Technical Bulletin #1610

Transmission: 41TE/42LE/42RLE
Subject: Check Ball Locations
Application: Chrysler
Issue Date: May, 2014

41TE/42LE/42RLE Check Ball Locations

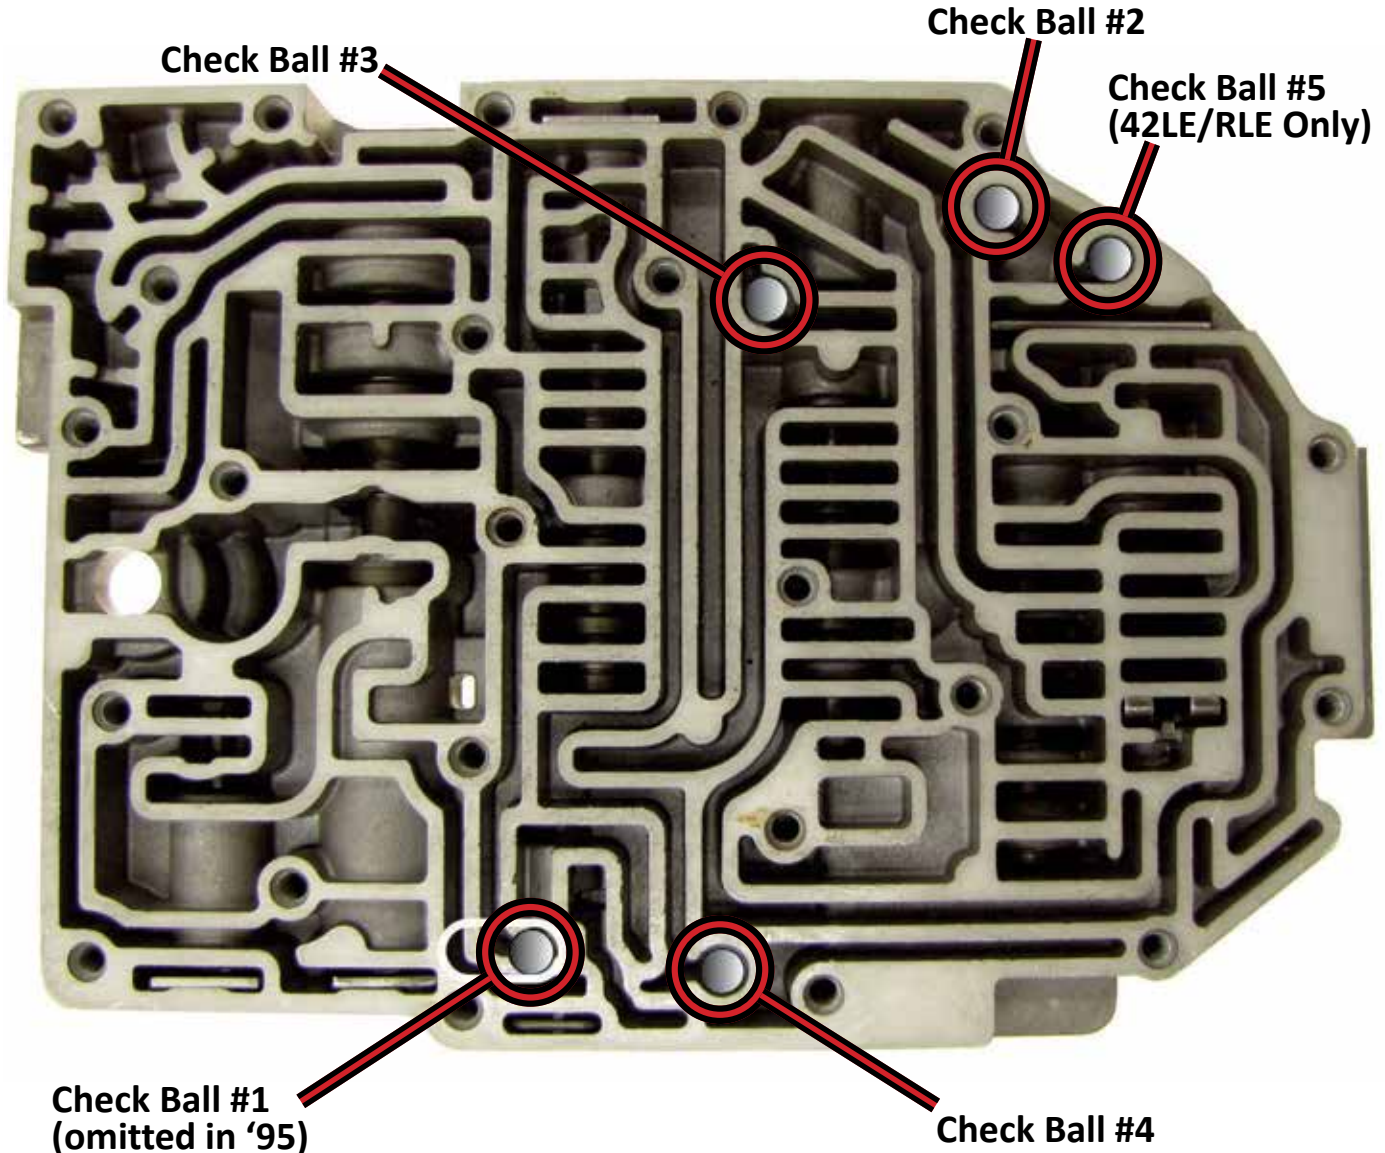
Check Ball #2 Was Eliminated in 2009 on the 41TE and 42RLE
(No Hole in that Location)

Late Valve Body Shown
(Earlier 41TE/42LE Valve Body has a #1 Check Ball Located in Bathtub)

Note: The capsule
changed to a 1/4"
check ball in 2007 with
variable line pressure
control.

Deleted in
2009
